# NS9775 / NS9750 / NS9750B-A1 / NS9360

## Reset Issue Change Notice

**Figure 1: NS97xx Clock Enable Configuration**

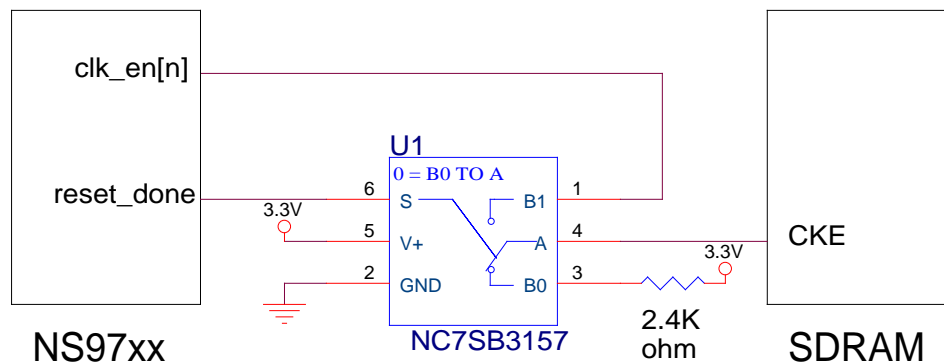
The SDRAM clock enable configuration for the NS9775, NS9750, NS9750B-A1 and NS9360 (NS9xxx) must be changed in order to prevent SDRAM devices from locking up during a manual or brown out condition reset following the initial power on reset. The only exception is if power is cycled automatically during a brown out condition reset and a manual push button reset is not used or if clock enables to the SDRAM devices are connected directly to 3.3V. Otherwise, the SDRAM devices can become locked up during a manual or brown out condition reset as follows:

1. A manual or brown out condition reset is applied to reset\_n on the NS9xxx.
2. At the same time, a read command is active to the SDRAM devices connected to the NS9xxx.
3. The reset\_n to the NS9xxx shuts off clocks and clock enables to SDRAM devices, preventing the read command from being completed.
4. The SDRAM devices become permanently locked up at this time. A power cycle is required to return the SDRAM devices to normal operation.

1. Connect the clock enables on the SDRAM devices directly to 3.3V or pull-up resistor.
2. Use a switch to connect clock enables to the SDRAM devices to a pull-up resistor until the NS97xx device reset is complete as indicated by a high level on the reset\_done output. A sample circuit is shown in Figure 1 below.
